City of Beaufort Department of Planning and Development Services

M E M O R A N D U M

SUBJECT: Conceptual Review of City Walk Subdivision Master Plan

▲ PROPOSED PEDESTRIAN AND BICYCLE INFRASTRUCTURE SECTORS 1, 2, 3, 5

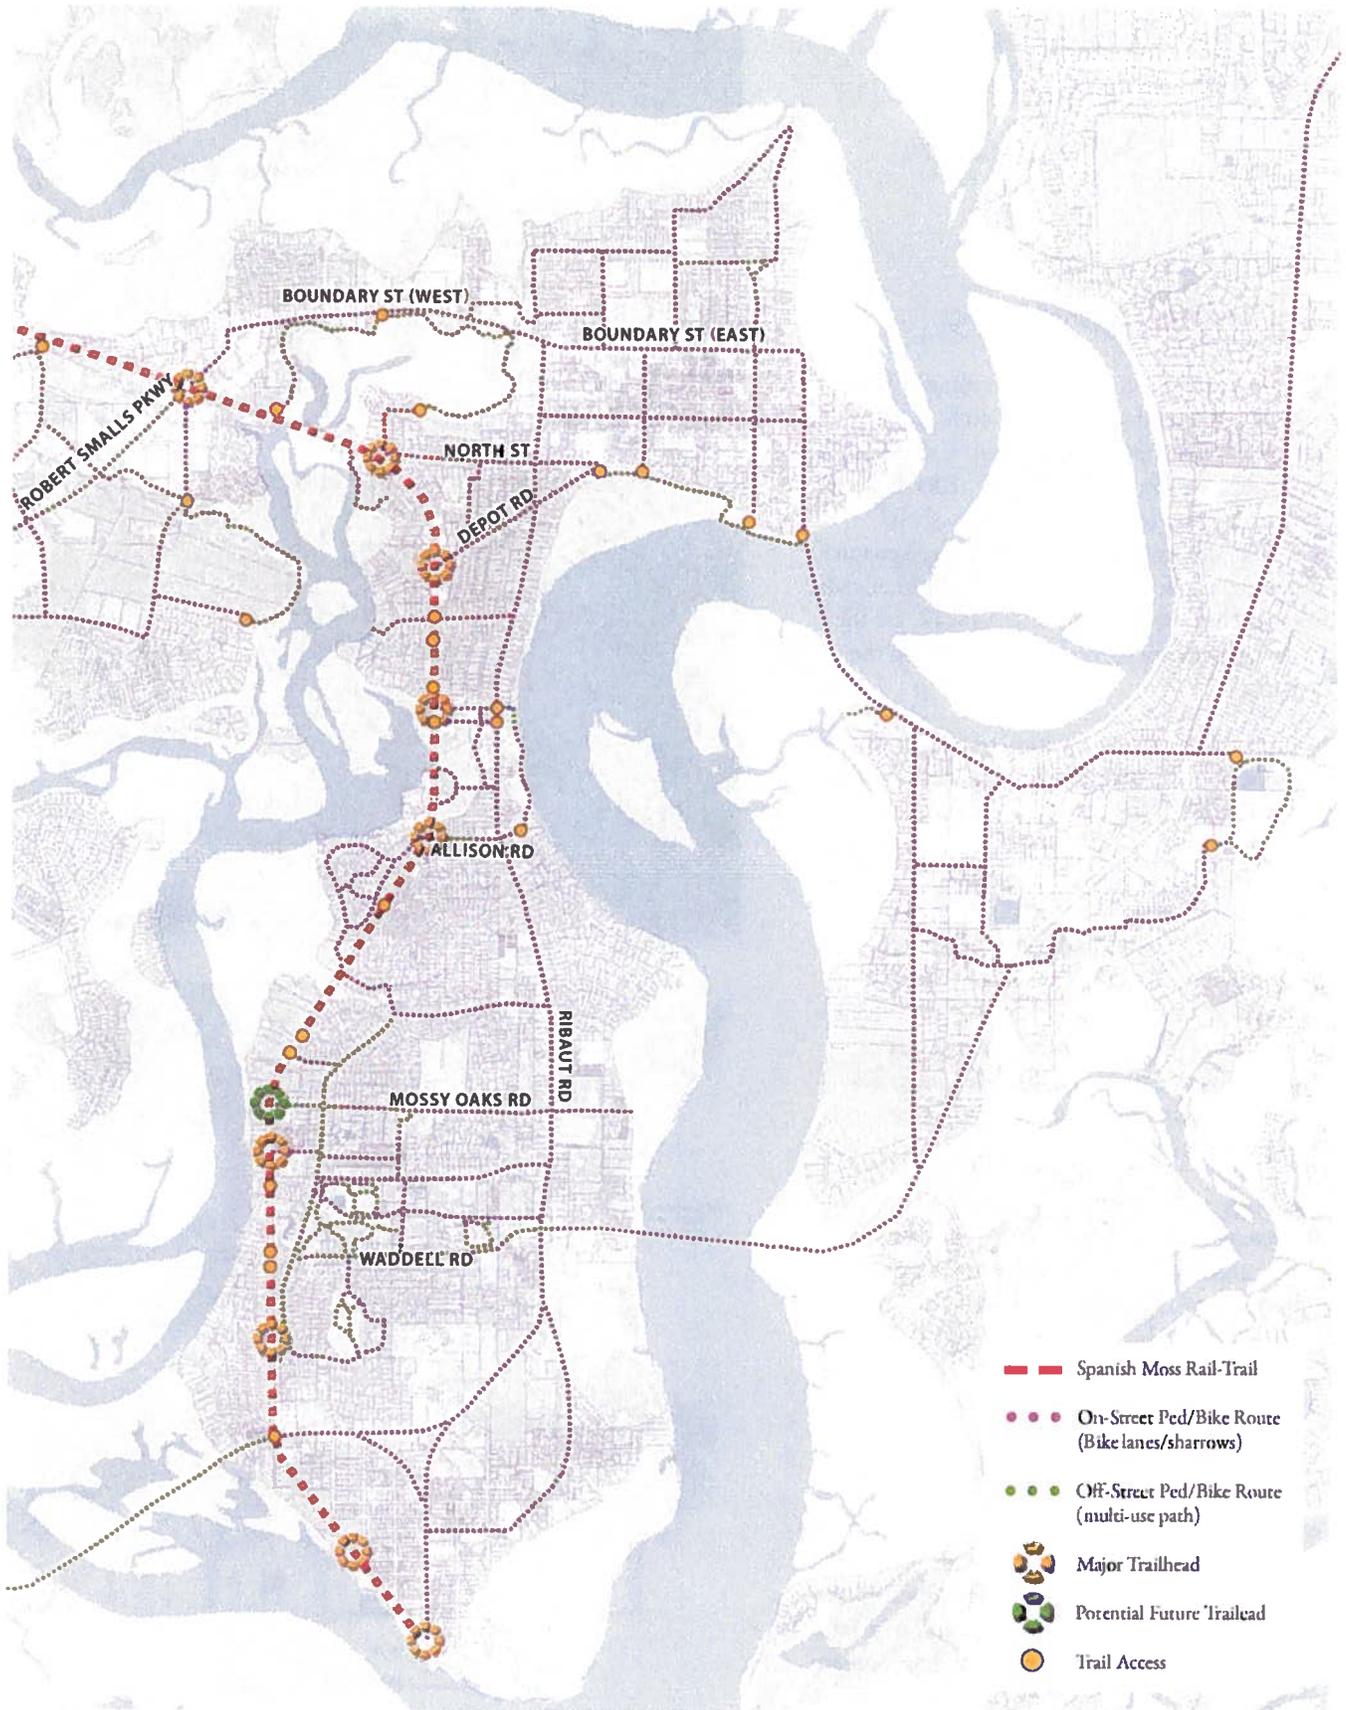
- *Approval of the amount, location, and type (active/passive mix) of open space.* The master plan appears to meet the minimum requirements for open space set out in the ordinance. In an effort to implement the “Battery Creek Basin greenway,” the multipurpose path shown on The Pedestrian and Bicycle Infrastructure Plan in the Civic Master Plan, staff recommends the Planning Commission require that a pathway easement be placed on the open space portion of the site where it connects to the adjoining property to the east, currently Park View Apartments (see attached excerpt from the Open Space Master Plan).

OPEN SPACE MASTER PLAN

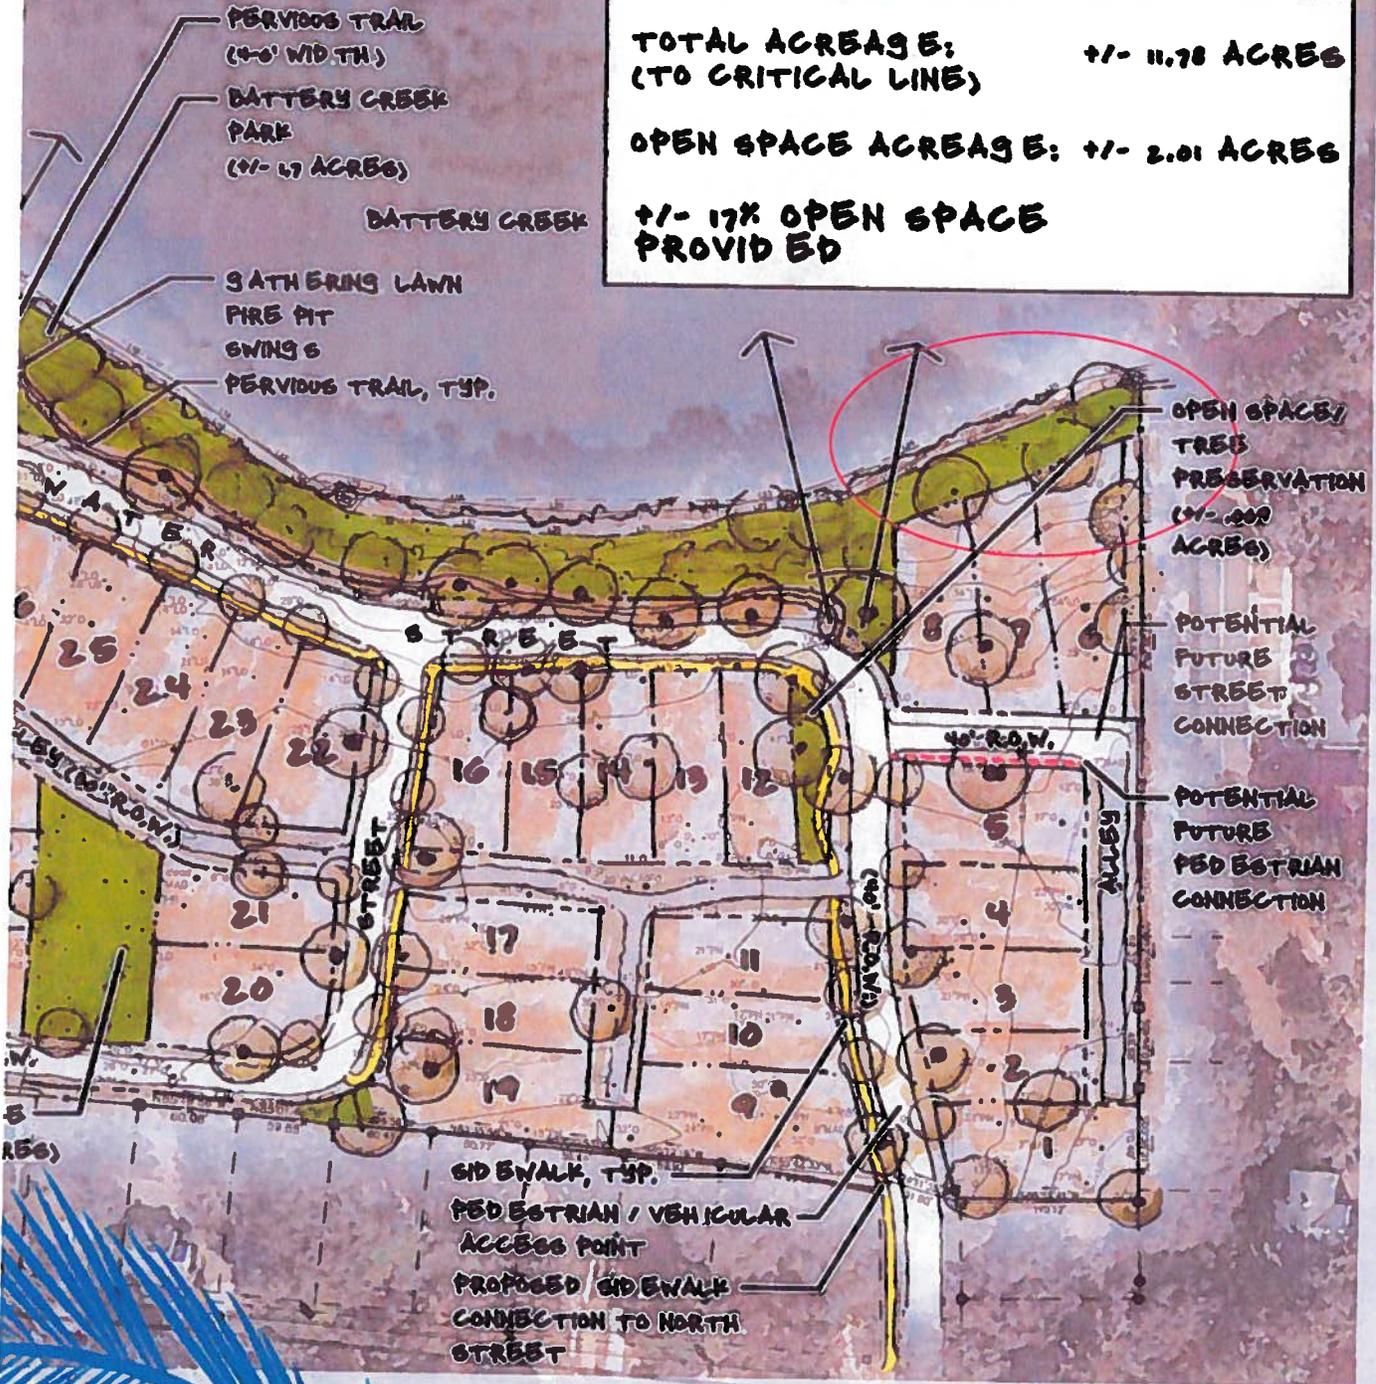
- *Approval of sidewalks on only one side of Water Street and the unnamed loop street.* Section 8.2.A.11 of the Unified Development Ordinance (UDO) requires sidewalks on both sides of all new streets, with the Planning Commission having the authority to waive this requirement “when alternative pedestrian ways or pedestrian /bikeways have been or will be provided outside the normal right-of-way; or that unique circumstances or unusual topographic, vegetative, or other natural conditions prevail to the extent that strict adherence to said requirements would be unreasonable and not consistent with the purposes and goals of this UDO . . .” Staff supports the request for this waiver.

- *Approval for no sidewalks on the unnamed potential future street connection at the east side of the site.* Staff supports this request.
- *Approval for not installing a sidewalk on Huguenin Drive.* Section 8.2. A.11 of the UDO requires that as part of major subdivision development, sidewalks be installed on existing streets. Staff would consider supporting a waiver of this requirement if the applicant provides justification based on grade changes and tree protection issues.

- *Approval for sidewalks 4’ wide.* Section 8.2.A.11 of the UDO requires sidewalks to be 5’ wide. Staff supports reducing the width of sidewalks to 4’ in areas where it will assist in tree preservation as determined by the City’s Certified Arborist.

- *Approval for creation of a block less than 300’.* Section 8.2.C.1 of the UDO requires that blocks be a minimum of 300’ in length. The block formed by the unnamed street at the east side of the site, is approximately 140’ in length. Staff supports this request.

- *Approval for not extending the alley into Tidal Street.* Section 8.2.A.2 of the UDO stipulates that “Where possible, existing streets shall be extended.” Staff recommends that the proposed alley be extended to connect with Tidal Street.

- *Approval for alleys with a 10' travel lane.* Section 8.2.A.13.b of the UDO requires alleys to have a minimum width of 12'. Staff supports this waiver.
- *Waiver of street tree planting requirement.* On the section of Water Street adjacent to the large open space, the applicant is proposing to only plant street trees on the south side of the street. Section 8.2.A.8 of the UDO requires street trees to be planted on both sides of all new streets. Staff recommends that tree planting on the south side of the Water Street ROW (adjacent to the open space) be determined jointly by the City's Certified Arborist and the applicant based on the arborist's report and by on-site inspection.
